**SUBMITTAL FOR APPROVAL OF REVISION -  
QA PROGRAM TOPICAL REPORT OF ADVANCED NUCLEAR FUELS**

ADVANCED NUCLEAR FUELS CORPORATION  
QUALITY ASSURANCE PROGRAM FOR NUCLEAR FUELS

SUMMARY OF CHANGES: (Indicated by \* in right margin)

FIGURE 1  
ADVANCED NUCLEAR FUELS CORPORATION ORGANIZATIONS  
(Related to Nuclear Fuel Design and Fabrication and Engineering Services)

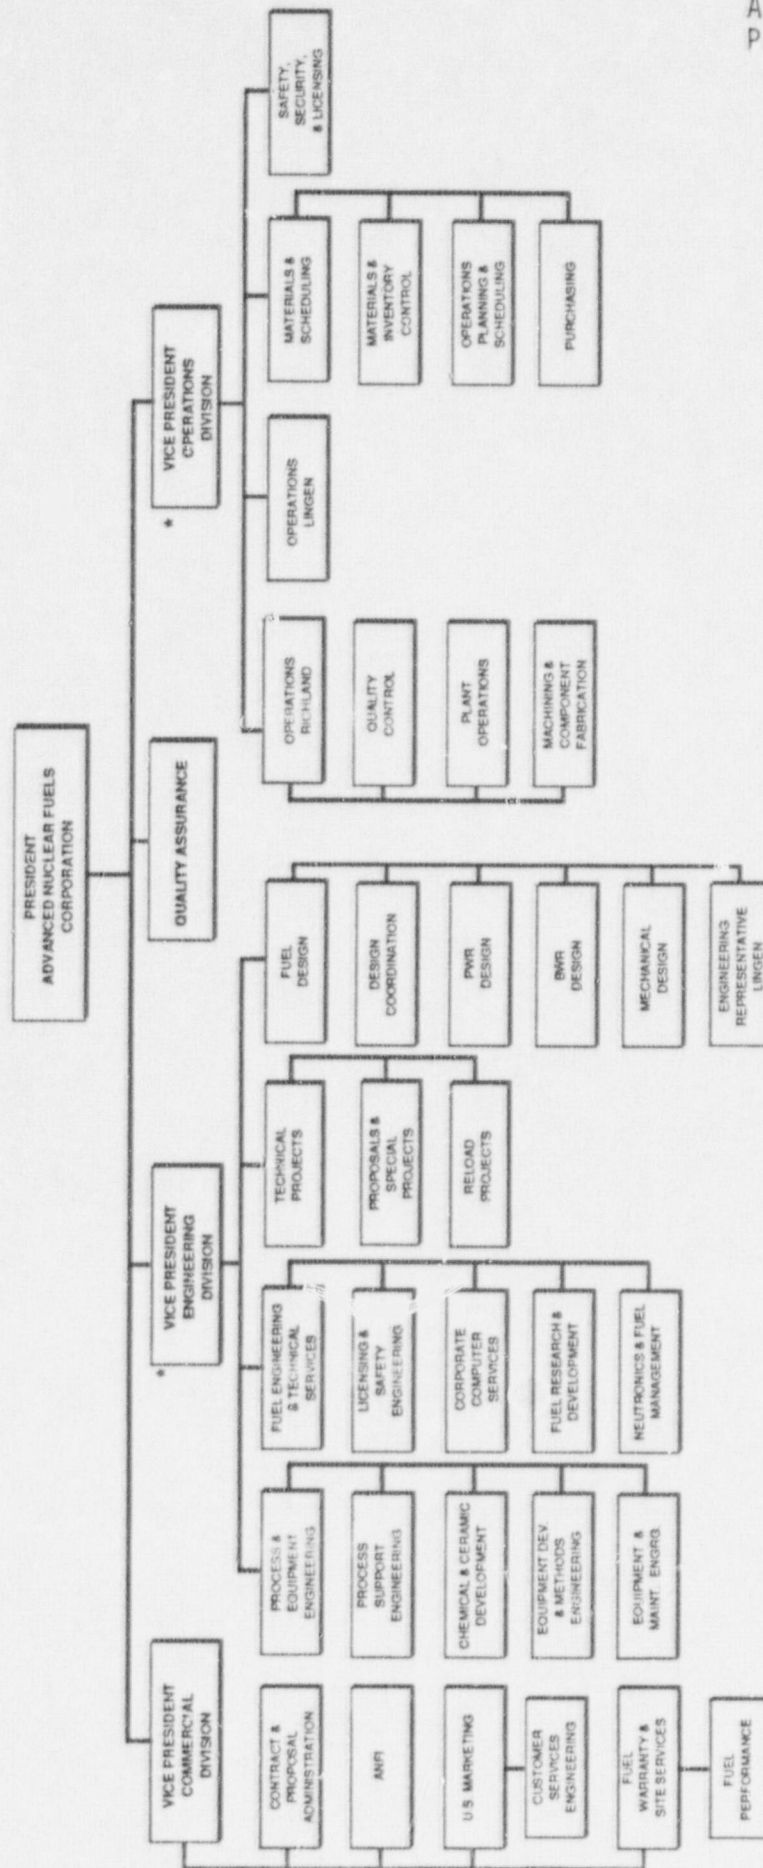
12. Figures 1 and 2 were revised to show current organization.
13. Various formatting changes (indenting, paragraph titles in Section 1) were made for consistency.
